Chatham County, NC

File #: 22-4412, Version: 1

Vote on a request by Ben Mayo, P.E. of Withers Ravenel on behalf of Windjam Development (RBV 1525, LLC) to approve for Subdivision First Plat review and approval of Flatiron Forest, consisting of 29 lots on 42.124 acres, located off Hamlets Chapel Rd (S.R. 1525), Parcel 2037.

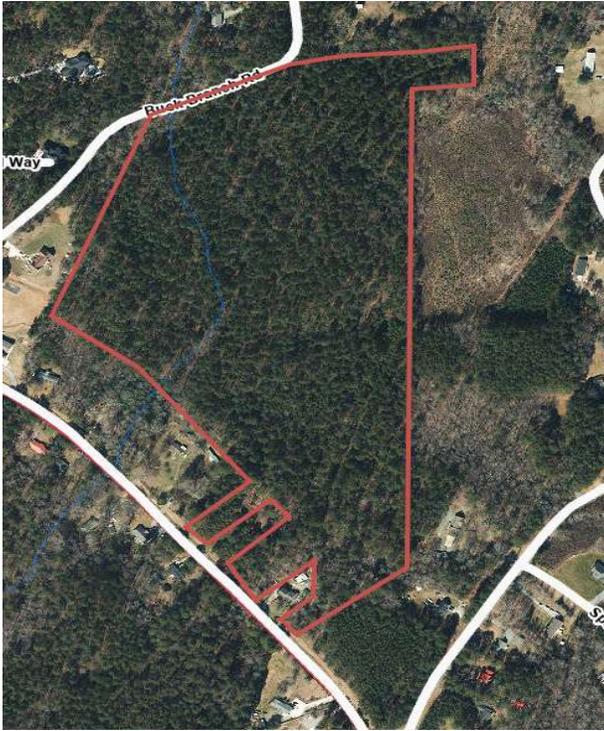
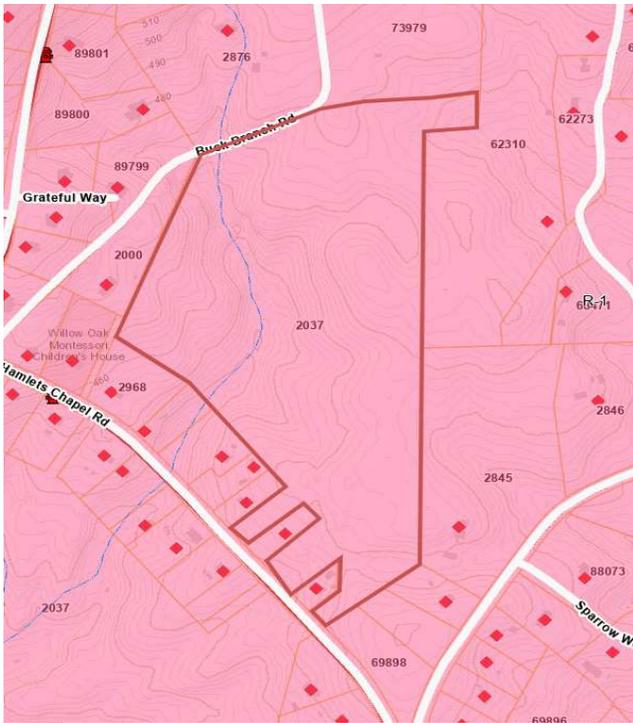
Technical Review Committee: The TRC met to review this project at their June 15th meeting. Planning staff informed the applicant that the minimum size for all the lots needed to be at least 40,000 square feet. The plat would need to be revised to show those changes and that has been done. Watershed staff said the plat was showing suitable soils within the buffer, which will need to be removed and that has been done. Also, staff raised concerns about lots 1,9, and 10 if they will have enough buildable areas with the septic area and buffers being show on those lots. Staff asked about the stormwater control measure (SCM) in front of lot 16 and if it was an easement or an open lot. Both SCMs would have their own open lot spaces. Watershed staff recommended extra care be taken in construction of the SCM because it was so close to a buffer.

Septic: According to Environmental Health septic field layouts will be needed for 1,2,6,7,11,16,22,28, &29 depending on the amount of suitable soils that will be available once the house sites are located. Central Carolina Soil Consulting, PLLC submitted a soil/site evaluation to the applicant on December 11th, 2021. The report is attachment 7.

There was some discussion if the applicant can make these changes before the July 5th Planning Board deadline. The new application and revised plats were provided to staff and have been included in the packets for the meeting.
